From:
To: [Edward Freedman](#); [Helen Webster](#)
Subject: FW: Atkinsons Wood Farm, Easby - Revised Plans
Date: 13 November 2018 16:17:06
Attachments:

Further to our ongoing discussions concerning Atkinsons Wood Farmhouse, please find attached a suite of revised plans, responding to the various issues we recently discussed.

Client:		G Yewdall	
Project:		Proposed Alterations to Listed Building Atkinsons Wood Farm, Easby	
Drawing:		Proposed Doors and Windows	
Status:	for Approval	Date:	25 March 2018
Drawn by:	djh	Checked by:	
Scale:	1:20@A1	Role:	
Project No:	17056	System:	ZZ XX
Originator:	SPA	Location:	DR
Volume:		Type:	A
Level:		Role:	[30] 01
Subsidiary:	S3	Subsidiary Description:	for Planning Approval
Rev:		Rev:	P03

Drawing:
Scheme Design
Proposed Plans & Elevations

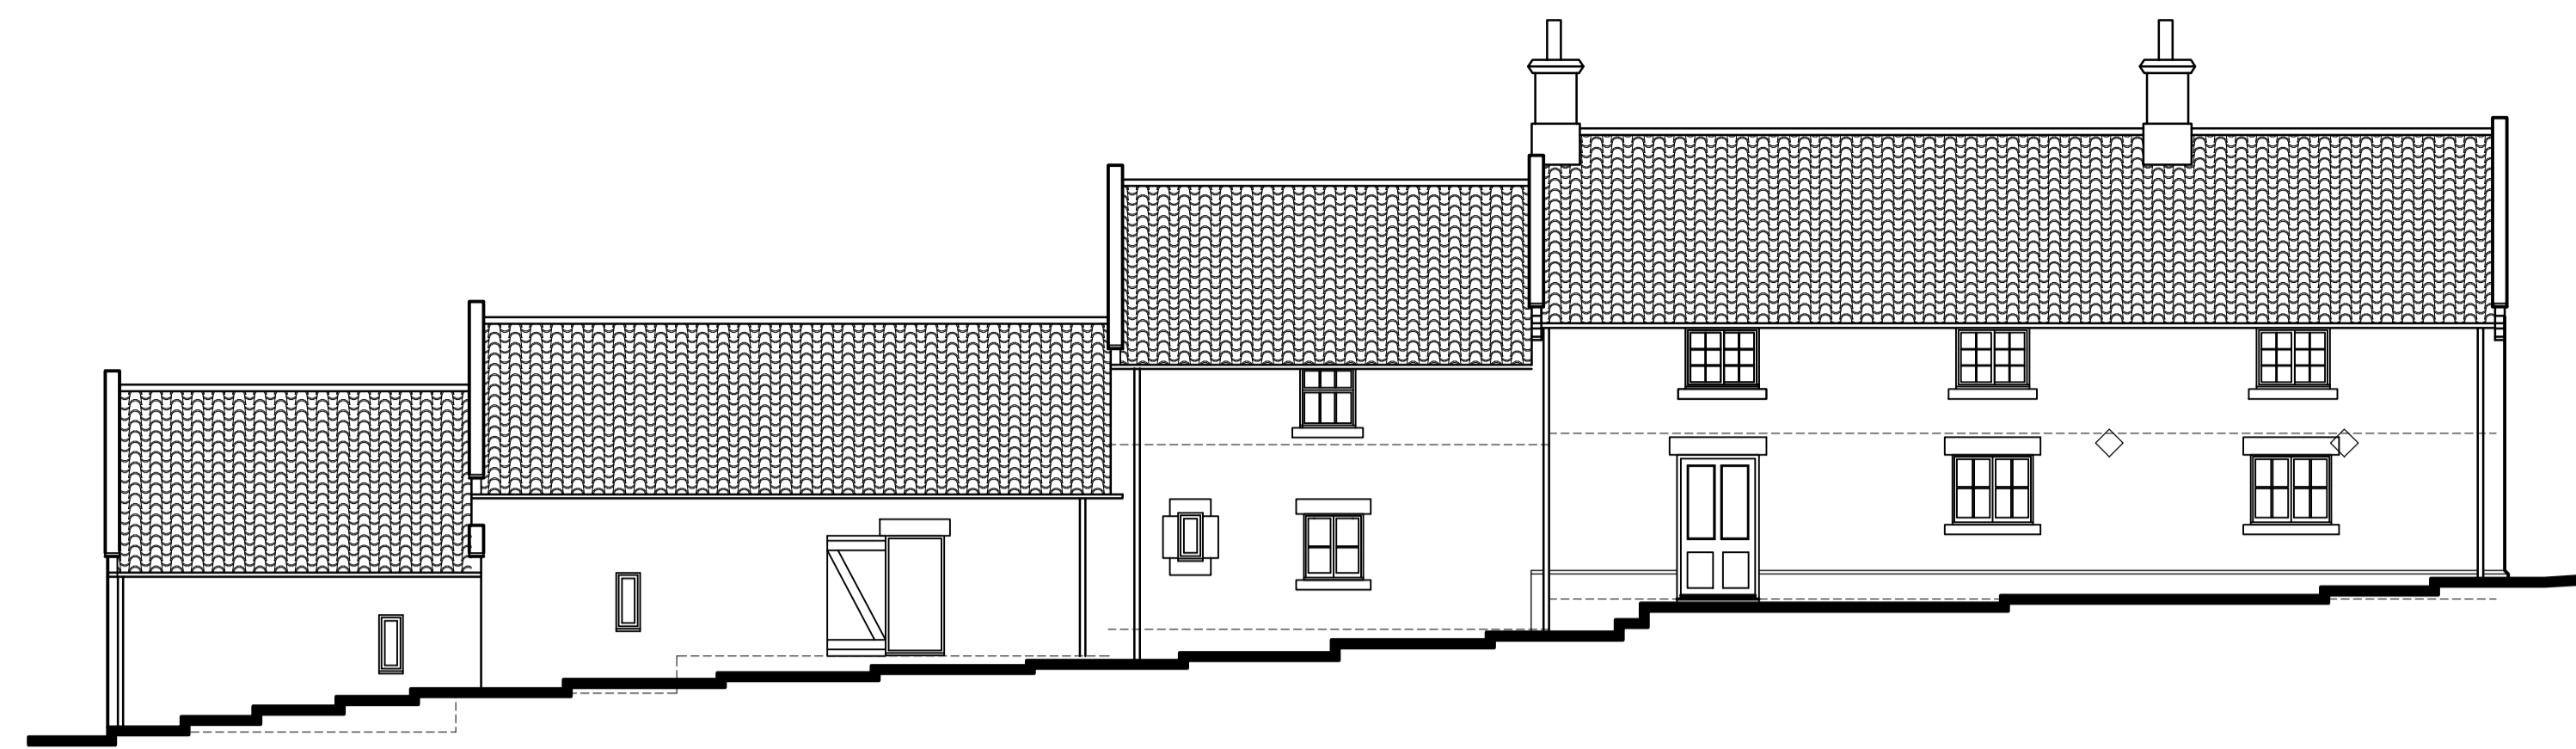
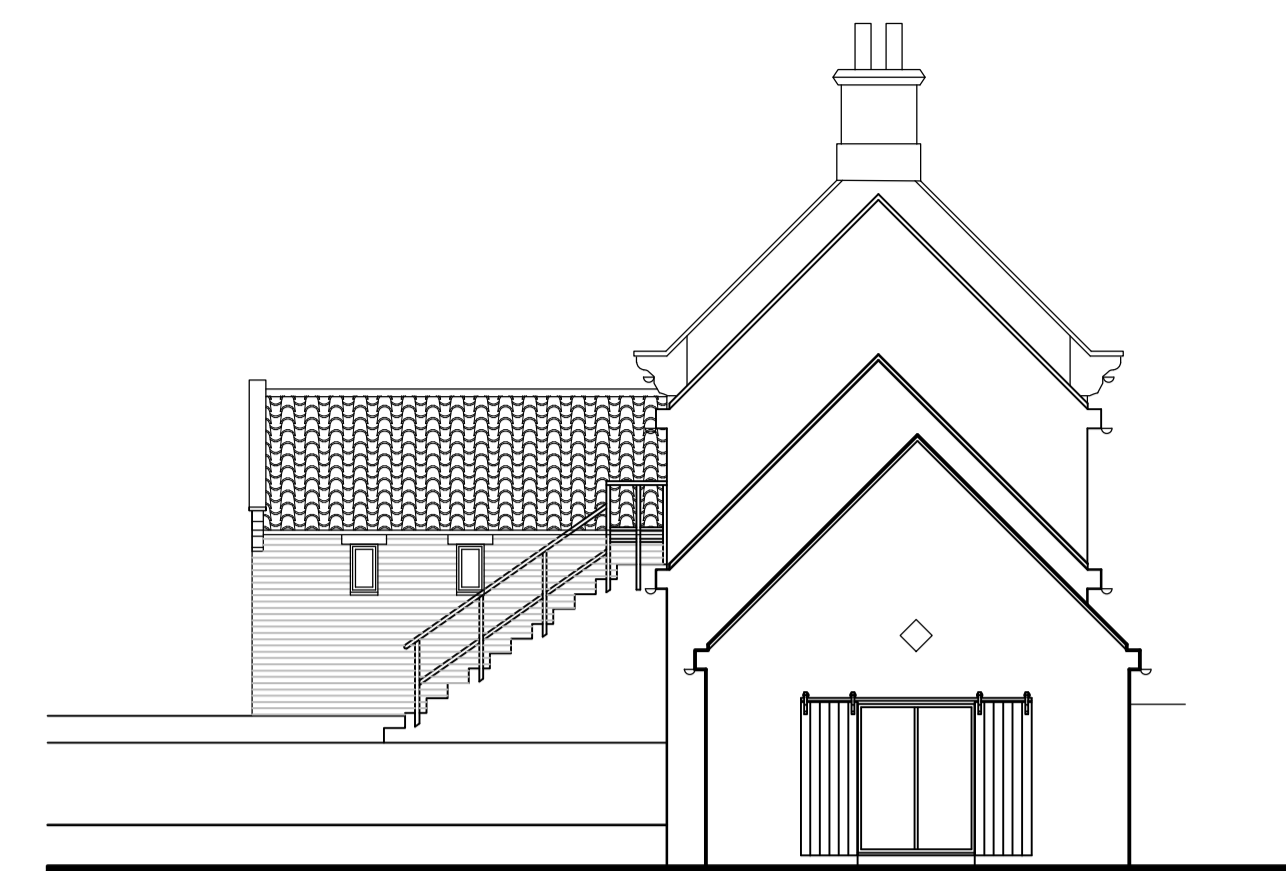
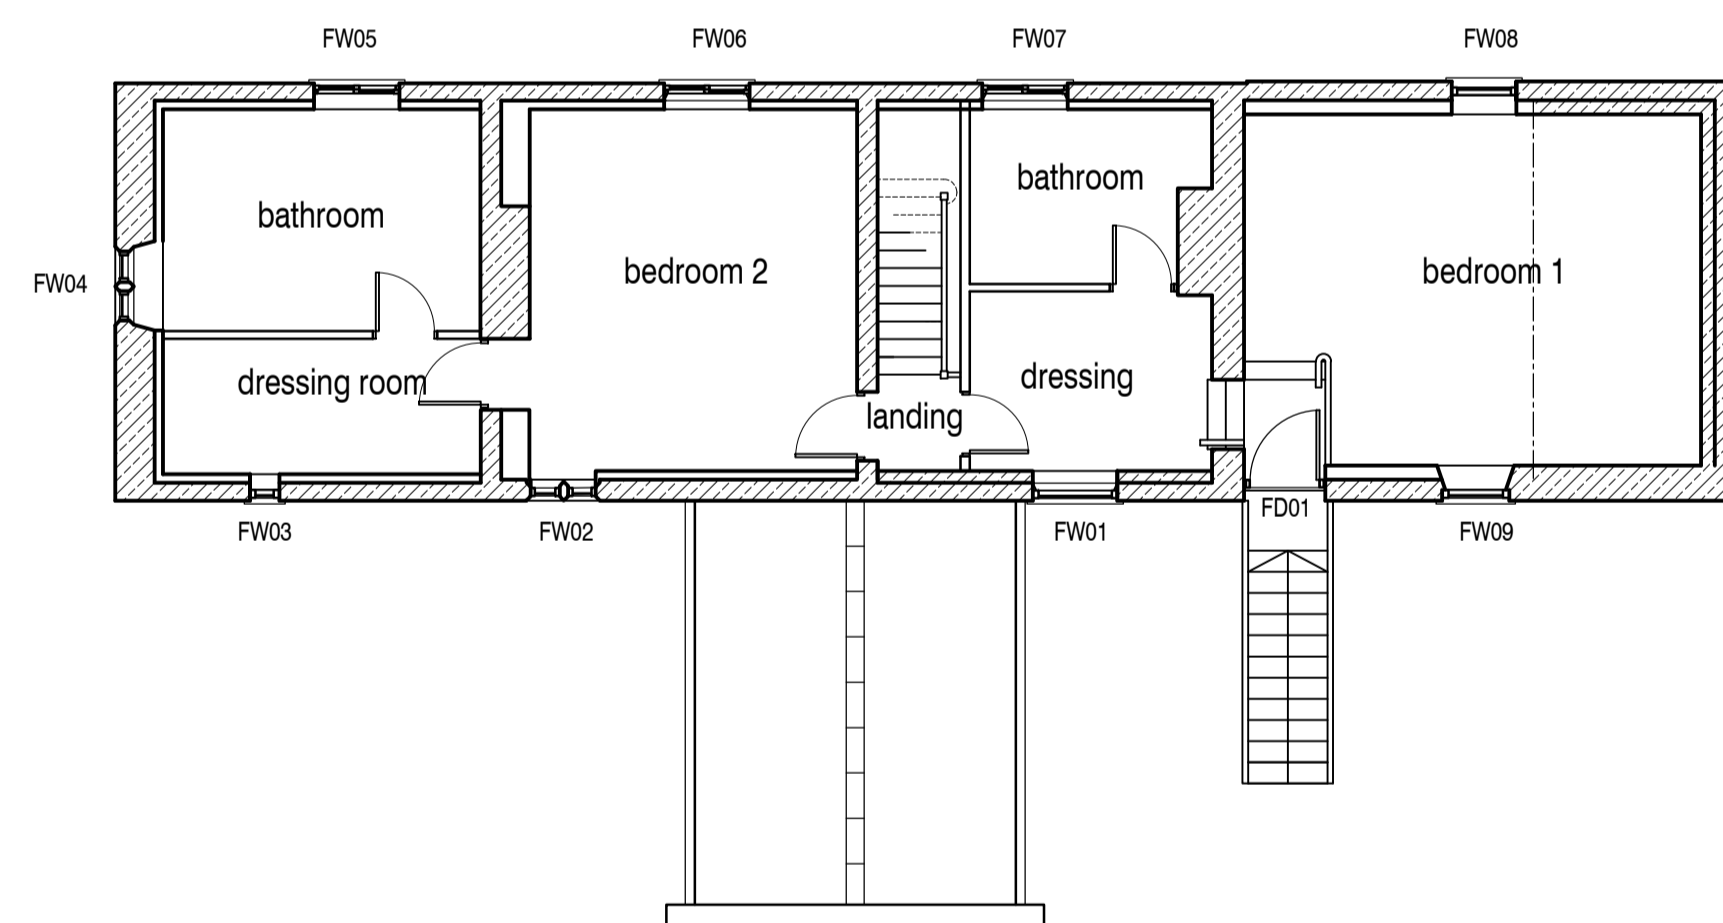
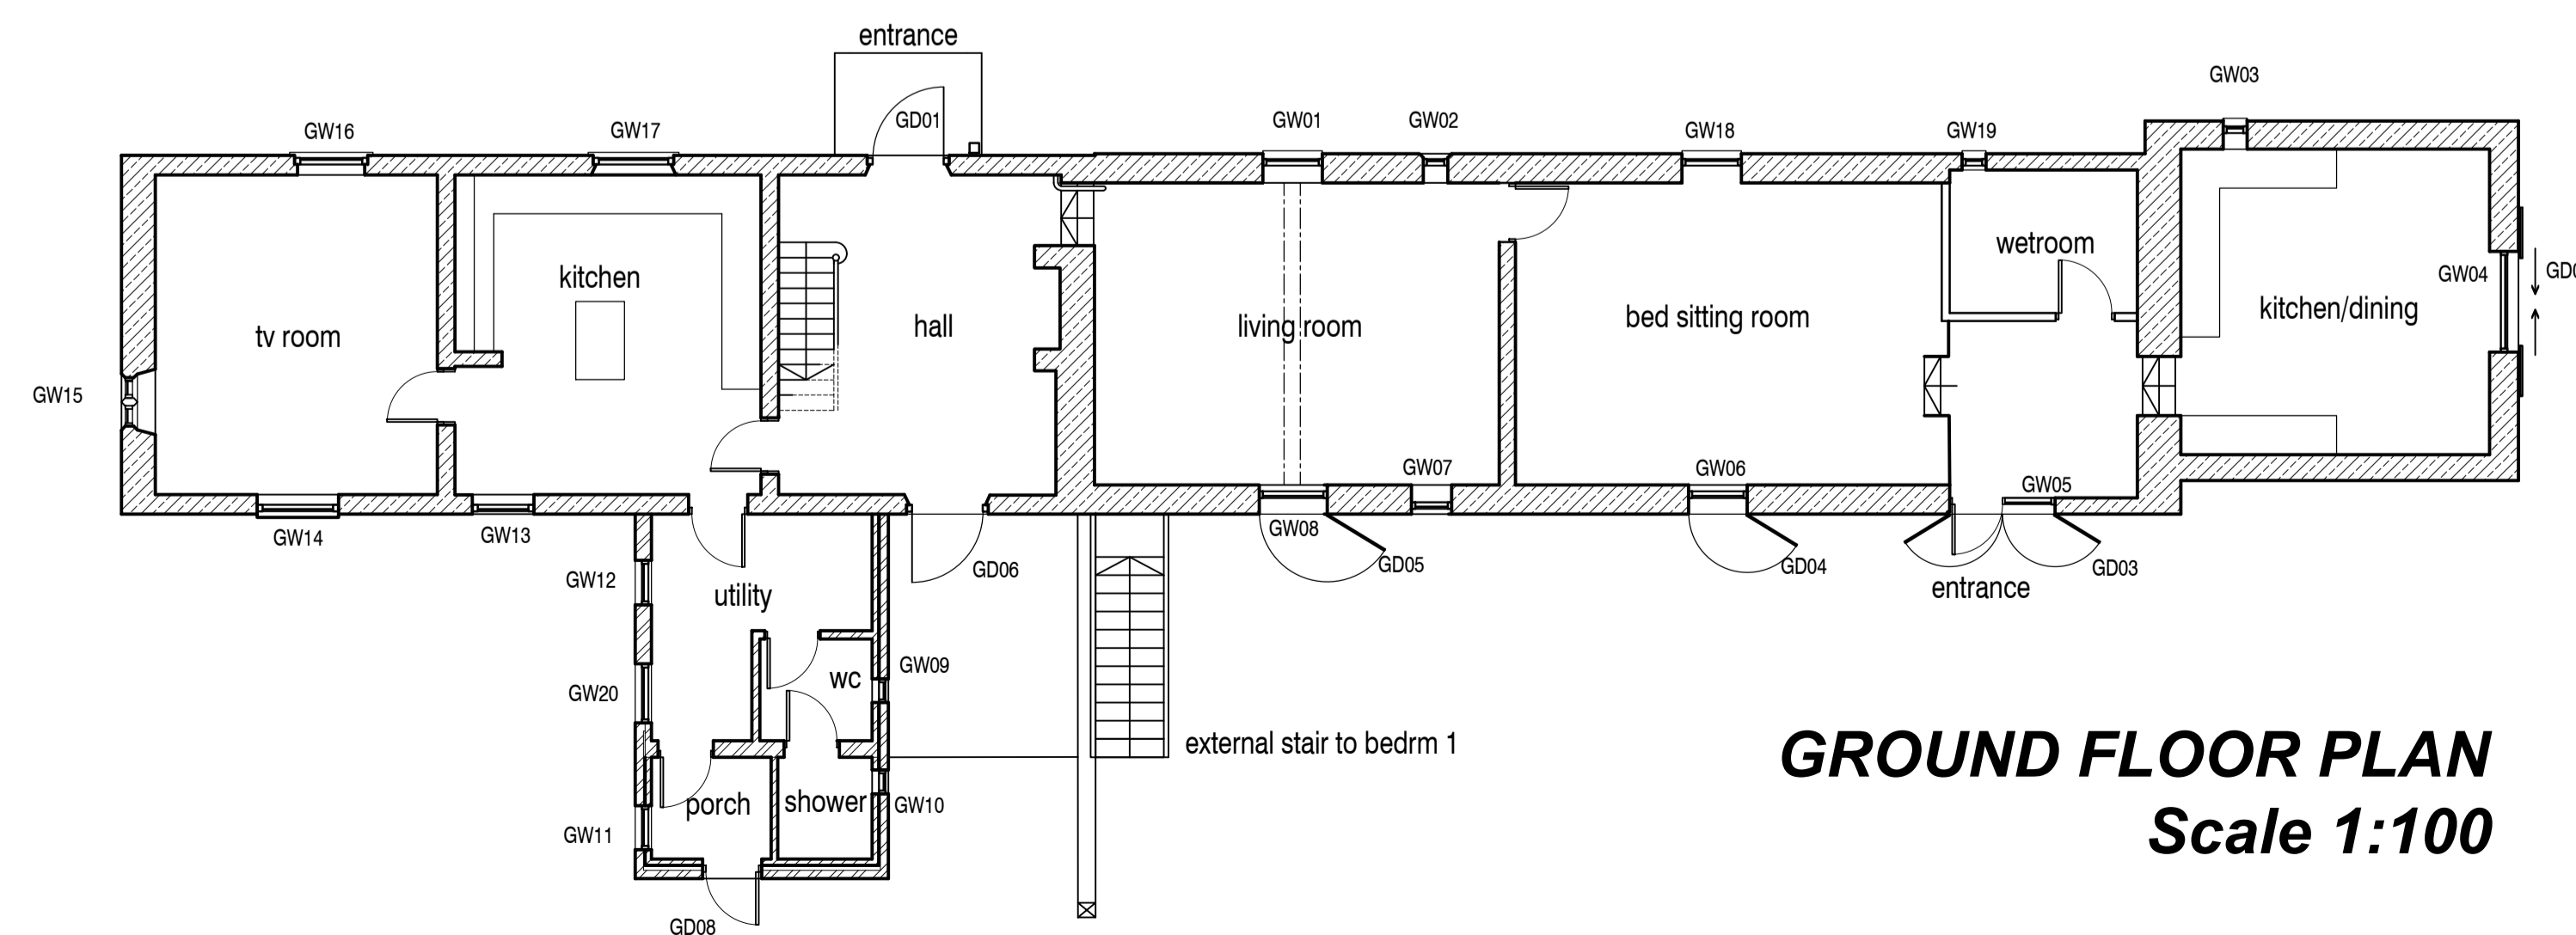
1. Double hung sashes revised to side hung flush casements for windows GW01, GW13, GW14, GW16, GW17
2. GW18 now has stable door added as with other barn door sized openings.
3. FW09 corrected to match elevation
4. Sliding doors added on detail elevation drawing for GD02
5. Sunroom and porch omitted together with door GD07
6. GD08 now repositioned to end of extension and with boiler room now renamed as porch. GW20 added at location of porch.
7. Detail drawing added for situations where there is a window in line with back of the masonry wall and stable doors fixed at the outside wall face. I have proposed simple 'farm' type hardware to the stable doors and sliding doors.
8. Elevations and plans revised to suit the above. GD 06 retained as external back door to Hall.

- E GD07, porch and sunroom omitted, GW20, GD02
- GD08 repositioned, barn door added to GW18
- GW13, 14, 16, 17 now SHC, as NYM mtg 08/10 24.10.18 djh
- D Sunroom revs. as reqd by NYM. W18.19 added 18.05.18 djh
- C Door and window refs added. Sunroom added 25.03.18 djh
- B plans/elevs revised for client 080218 telecon 16.02.18 djh
- A plans/elevs revised after 051217 NYMNP mtg 17.01.18 djh
